ADDENDUM #5

Project Name:
Iowa School for the Deaf (ISD) Girls Dormitory Repairs
DAS# 9356.00
RFB 935600-01
Addendum #5
Dated: October 10, 2024

PROJECT: DOE ISD GIRLS DORMITORY REPAIRS
 8001 HARRY LANGSTON DR., CORNELL, IOWA 51608
 CLIENT: IOWA DEPARTMENT OF ADMINISTRATIVE SERVICES
 SHEET: FIRST FLOOR PLAN

General Asbestos Abatement Locations
 Addendum #005
 10-04-2024

PROJECT NO. 105023A
 9356.00
 RFB #935600-01
 SHEET: A1.2

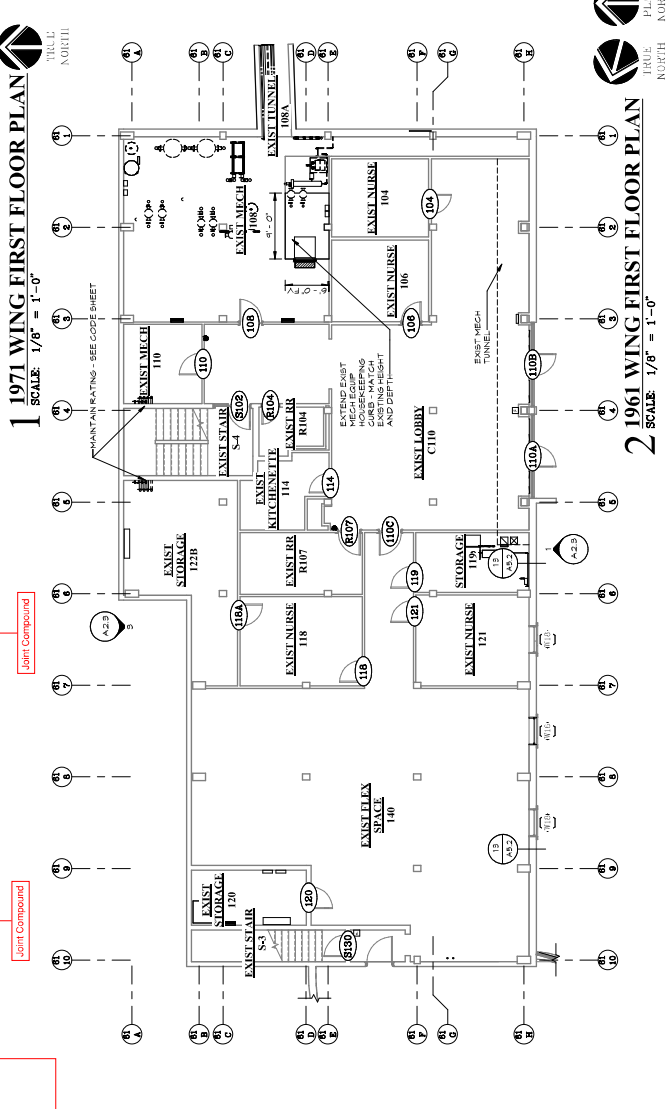
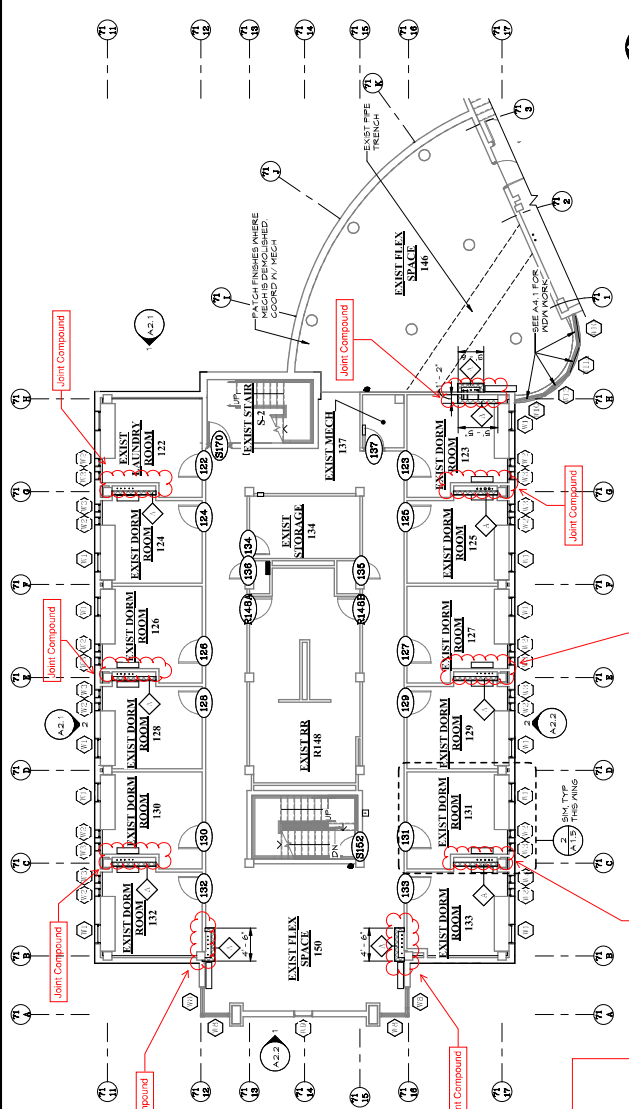
- A. Coordinate asbestos abatement and abatement schedule with the construction manager. Attached general asbestos abatement locations are for reference, coordinate actual quantities and removals with construction manager, specification sect. 02 080, and Hazardous Building Materials Survey Report.

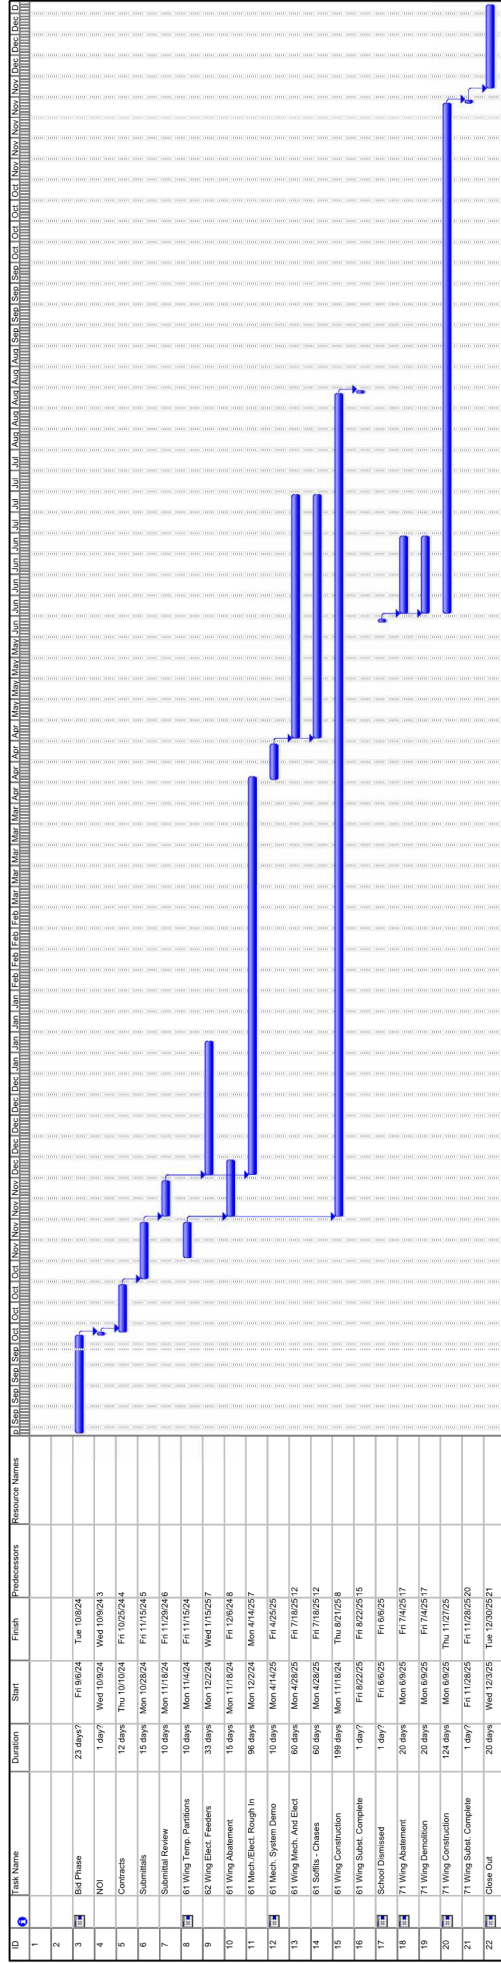
See Specification Section 02080
 61 Wing Abatement - Starts November 2024
 71 Wing Abatement - Starts June 2025
